Device TC23x
Marking/Step ES-AB, AB
Package see Data Sheet

10209AERRA

This Errata Sheet describes the deviations from the current user documentation.

Figure 1 Message buffer transfer from Message RAM to OBF

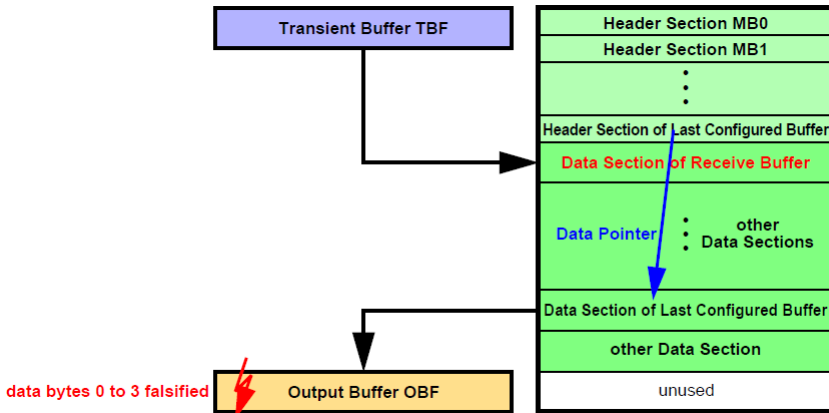
a) When a message is transferred from the Last Configured Buffer in the Message RAM to the OBF and **PLC** = 127 it may happen, that at the end of the transfer the OBF word on address 00h (payload data bytes 0 to 3) is overwritten with unexpected data (see [Figure 1](#)).

Figure 2 Message buffer transfer from IBF to Message RAM

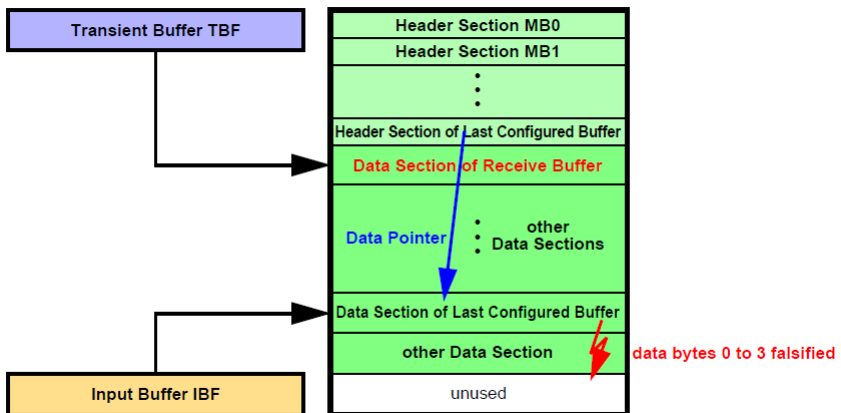
b) When a message is transferred from IBF to the Last Configured Buffer in the Message RAM, it may happen, that at the end of the transfer of the Data Section one additional write access overwrites the following word, which may be the first word of another message's Data Section in the Message RAM (see [Figure 2](#)).

Figure 3 Message RAM Configurations

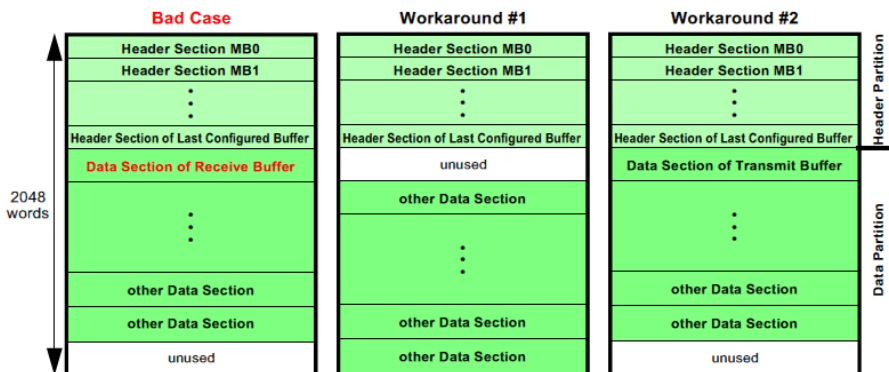
The erratum is limited to the case when (see [Figure 3](#) “Bad Case”):

2) Ensure that the Data Section directly following the Header Partition is assigned to a transmit buffer.

Figure 5 Recommended Software Handling - Flowchart

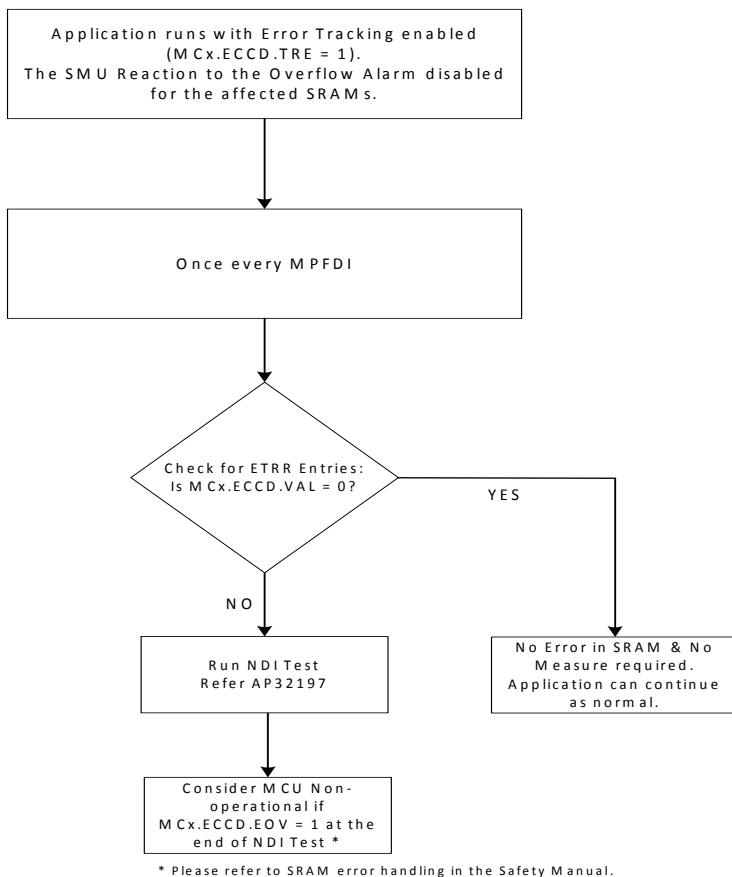
A flowchart of the recommended software handling is shown in [Figure 5](#).

If there is at least one valid ETRR entry (i.e. $MCx.ECCD.VAL \neq 0$) then the software shall run a Non-Destructive-Inversion (NDI) Test on the affected SRAM. Please refer to application note AP32197 (AURIX™ Memory tests using the MTU) for an example regarding running this test.

At the end of this test, if an ETRR overflow is detected ($MCx.ECCD.EOV = 1_B$) then the MCU shall be considered non-operational. Refer to section on Correctable SRAM Error handling in the Safety Manual.

Figure 6 Transmitter - winning CAN FD node

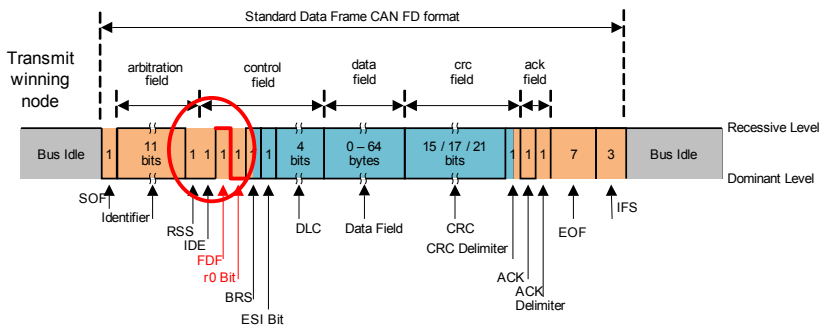
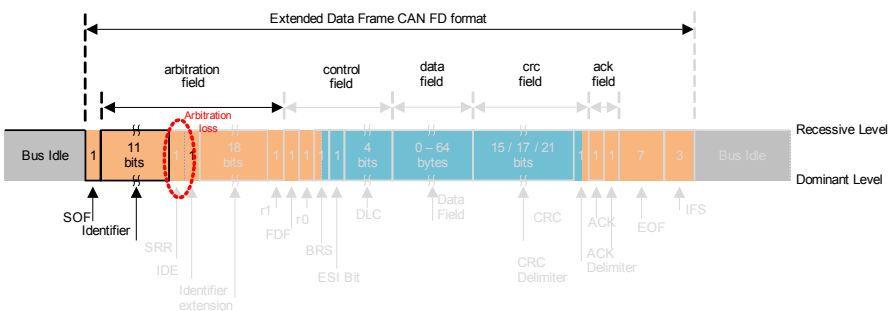
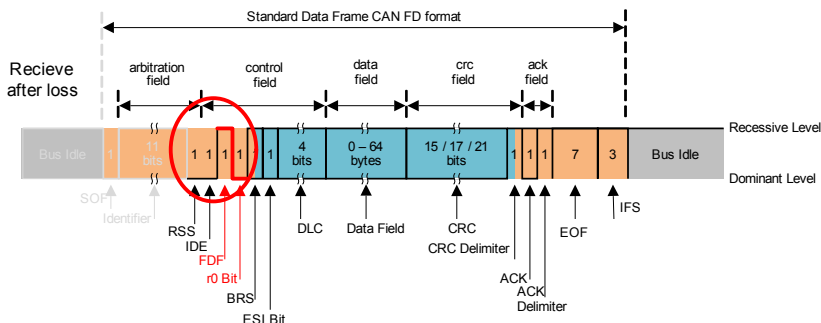
If a transmitter is losing arbitration late (e.g. in an extended frame - see [Figure 6](#) the node which wins arbitration and [Figure 7](#) the transmitting node loosing

arbitration), then the FDF bit to res bit is the last chance to synchronize to the winning node (here as a receiver **Figure 8** the same node as in **Figure 7**). A timing offset will occur between the now receiving node and the actual transmitter.

Figure 13 Short Serial Message, Serial Data Encoding over 16 messages

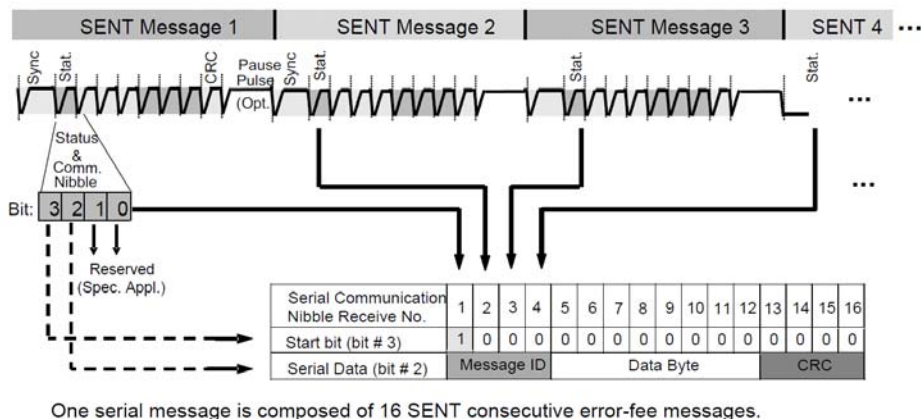
Figure 13 shows a corrected version of this figure.
